Service Manual

74CD53/21B/22B/25B/21G/22G
74CD63/21B/22B/25B
CD-63MKII U, F

Compact disc player

DIFFERENCE LIST

SCHEMATIC DIAGRAMS

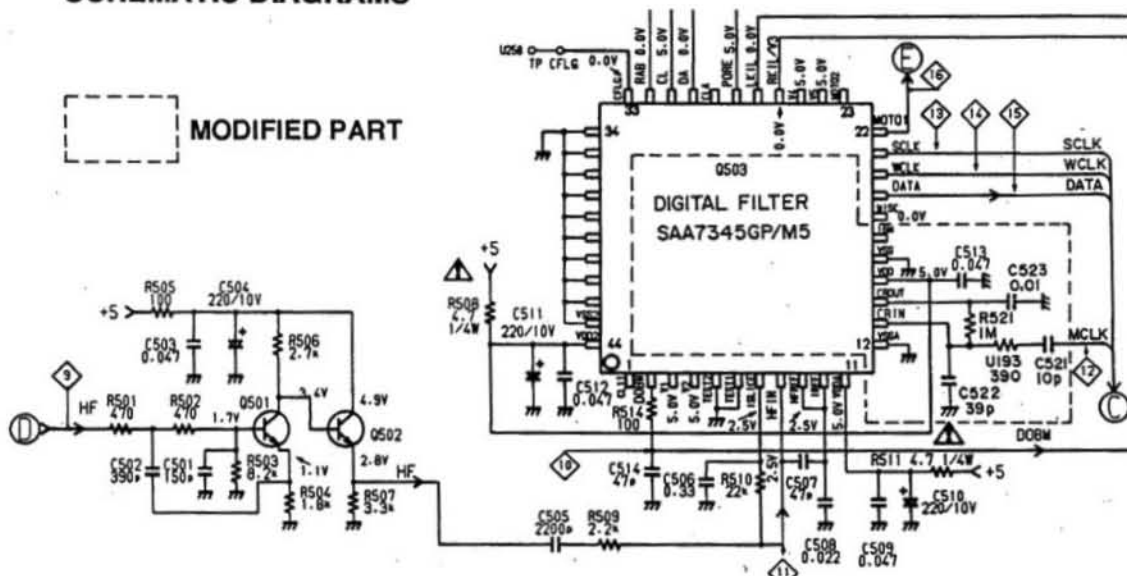
REMARK : This service manual explains them by extracting the different specifications of the "Front panel part" and some components were changed to new design for the model CD-53MKII and CD-63MKII based on the model CD-53 and CD-63.

POS.NO	VERSION OR COLOR	PART NO. (FOR EUROPE)	DESCRIPTION	PART NO. (FOR U.F.)
C521 C522 C523		4822 122 32185 4822 122 31069 4822 122 40586	COMMON CERAMIC CAP. 10pF $\pm 0.5\text{pF}$ CERAMIC CAP. 39pF $\pm 5\%$ CERAMIC CAP. $0.01\mu\text{F}$ $\pm 20\%$	DD11100300 DD15390300 DA17103110
R521 U193		4822 116 52235 4822 116 73391	RESISTOR $1\text{M}\Omega$ $\pm 5\%$ 1/6W RESISTOR 390Ω $\pm 5\%$ 1/6W	GD05105160 GD05391160
Q503		4822 209 33339	IC SAA7345GP1M5	HC10128490
003B	/21B/22B/25B /21G/22G	4822 459 04024 4822 459 04023	CD53MKII FRONT PANEL (BLK) FRONT PANEL (GLD)	285K248050 285K248150
001T	/21B/22B/25B	4822 736 14041	USER GUIDE (D.F.U.)	423W851310
C611 / C614		4822 124 22238	ELECT CAP. $100\mu\text{F}$ 25V	OA10702550
003B		4822 459 04025	CD63MKII FRONT PANEL	285K248060
001T	/21B/22B/25B F U	4822 736 14041	USER GUIDE (D.F.U.) USER GUIDE (D.F.U.) USER GUIDE (D.F.U.)	423W851310 423W851110 423W851250

R149 R150 R164 R165 R613 / R616		NSP NSP NSP NSP 4822 116 83036	JUMPER WIRE JUMPER WIRE JUMPER WIRE JUMPER WIRE RESISTOR 27Ω $\pm 2\%$ 1/4W FUSE	NSP NSP NSP NSP RF02270140
L001	/21B /22B/25B U F	4822 146 10354 4822 146 21793	MAINS TRANSFORMER MAINS TRANSFORMER MAINS TRANSFORMER MAINS TRANSFORMER	TS15734060 TS15734050 TS15734070 TS15734080

SCHEMATIC DIAGRAM

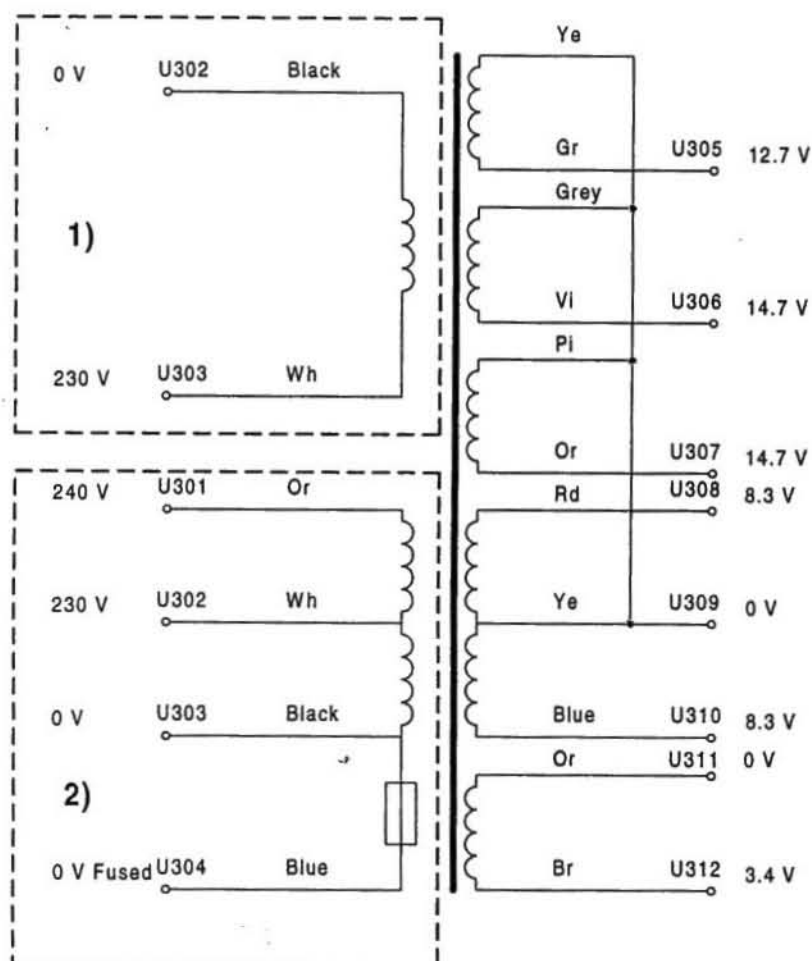
This service manual gives the electrical differences between the CD63MKII (CD63/22/25) and the CD63KI (CD63/92/95).

POS. NO	PART NO.	DESCRIPTION
L001	4822 146 10377	TRANSFORMER (/92/95)

- 1) Primary winding for sets with yellow dot on serial number label.
- 2) Primary winding for sets with blue, red, green or white dot on serial number label
